Application for Licence

Licence Number	L9450/2024/1
Applicant	LRL (AUST) Pty Ltd
ACN	610 981 194
File number	DER2024/000439
Premises	Kathleen Valley Lithium-Tantalum Project Mining tenements M36/265, M36/459, M36/460, M36/696, G36/52, L36/255, L36/256 As depicted in Schedule 1 of the licence
Date of report	23 June 2025
Decision	Licence granted

Figure 2: Locations of the dual-use flood levy/LV access road and amended diversion channel

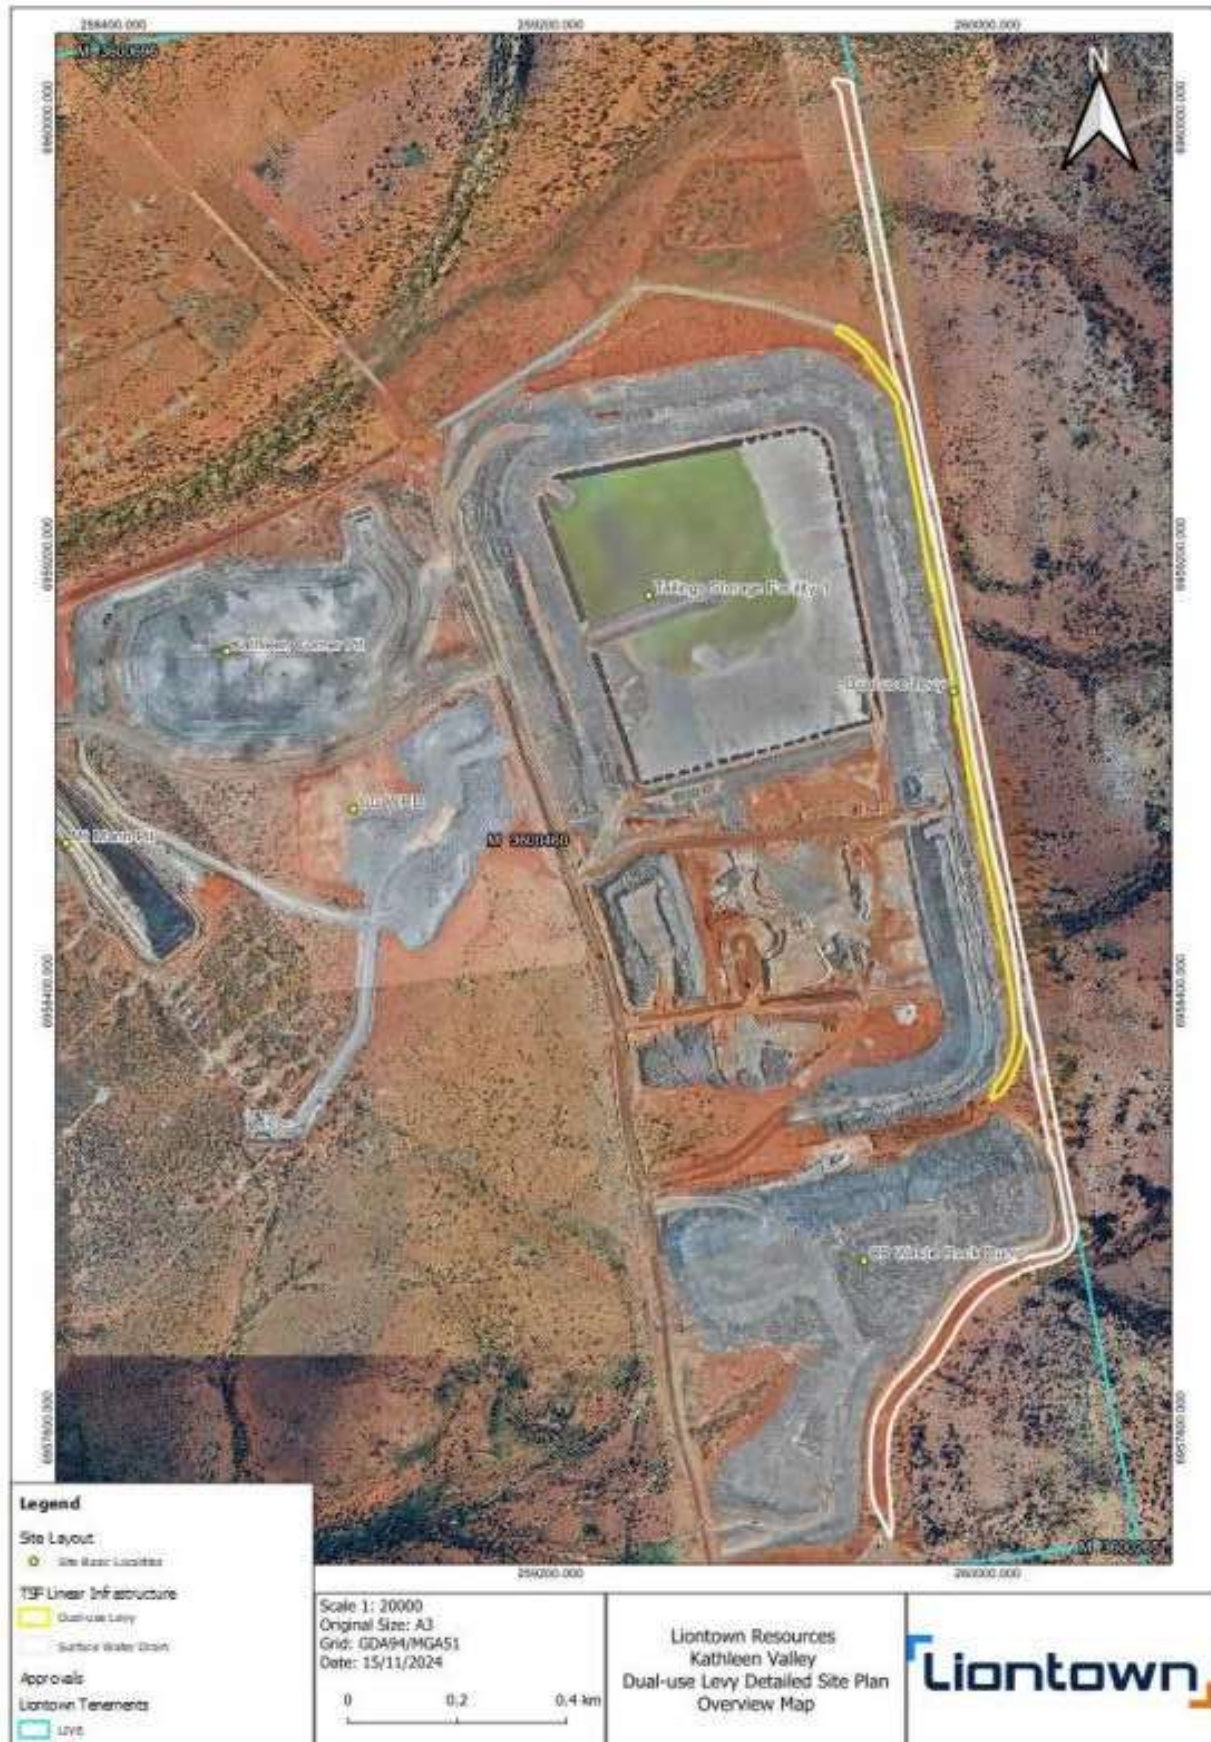
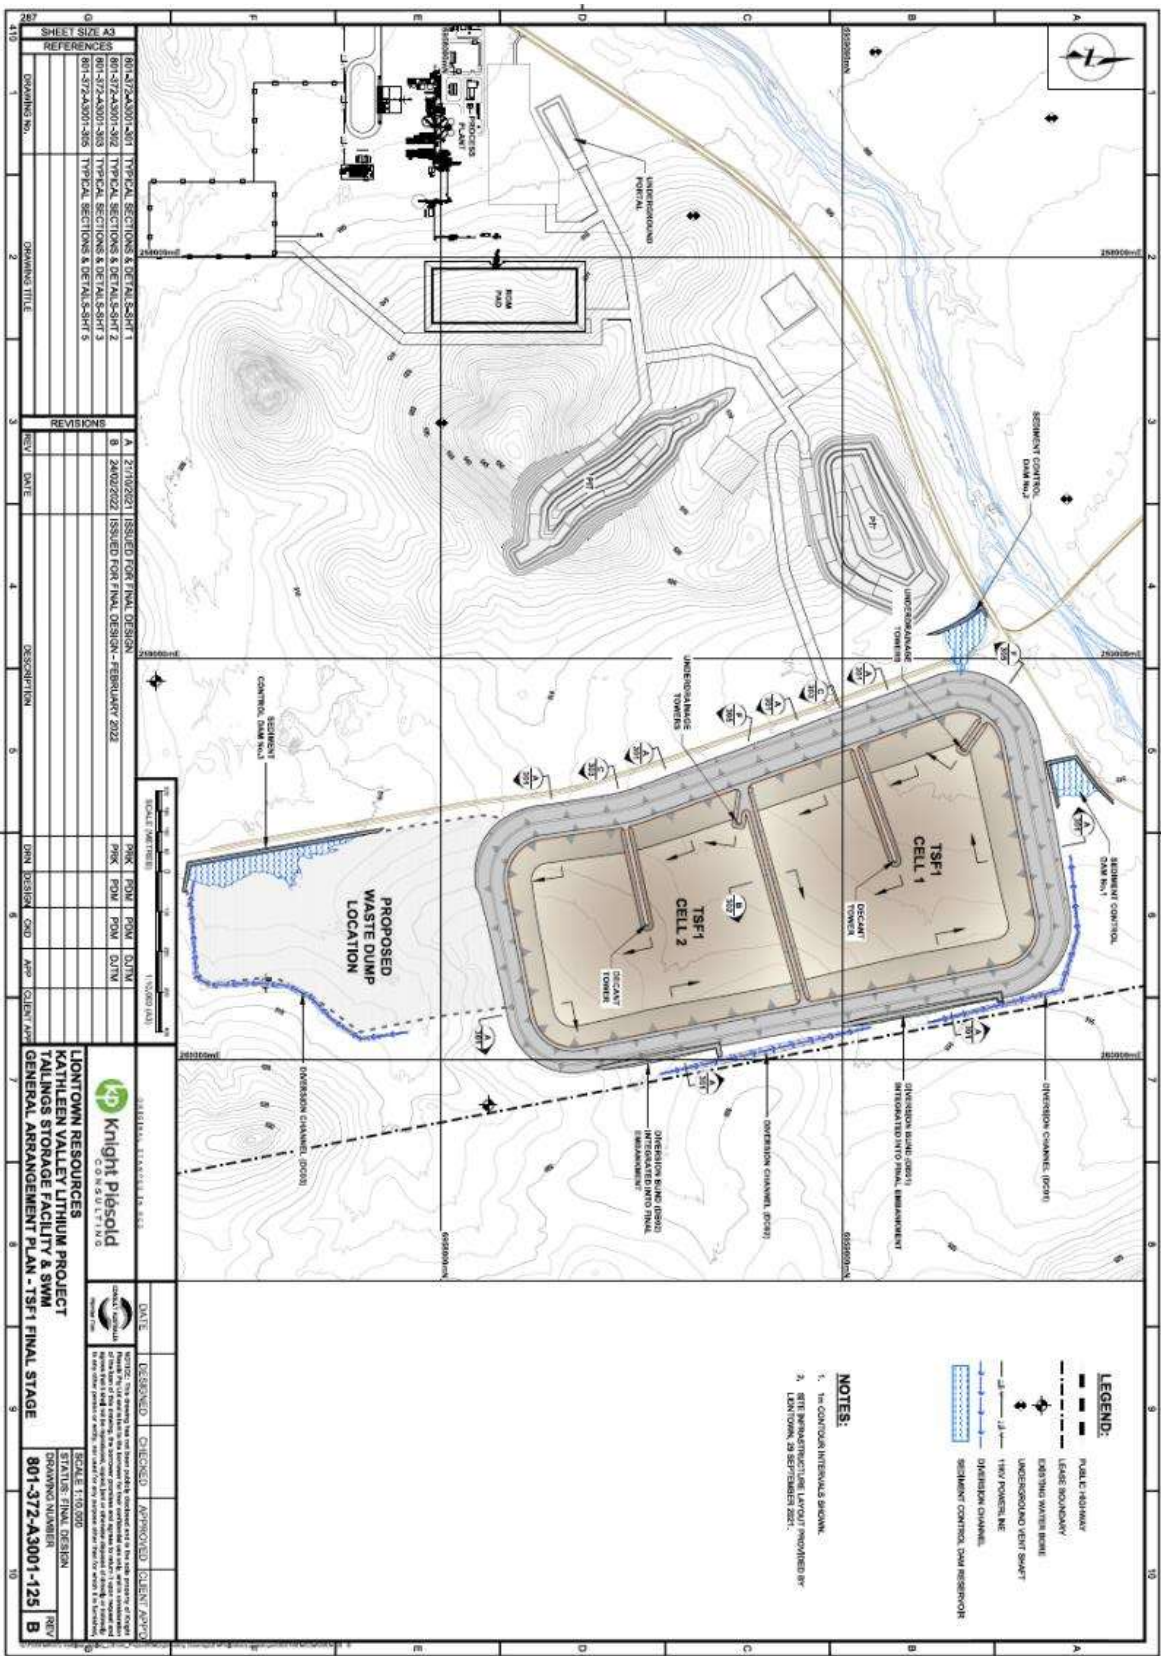
The diversion channel is located along TSF1 and the waste dump location, and is used to divert stormwater around TSF1 and direct the water into Jones Creek. The design of the diversion channel has been amended and is now one continuous channel, compared to the original design that included three separate channels. The amended design extends further north towards Jones Creek instead of west along the northern edge of TSF1 Cell 1, and is no longer located along the southern edge of the waste dump location. The amended design considers a 1% AEP (1 in 100) event, consistent with the original design (MBS Environmental 2022). Construction of the diversion channel was completed on 8 April 2025.

The amended and original designs are shown in Figure 2 and Figure 3.

The changes to the design of the diversion channel are not considered to increase the risks to the environment.
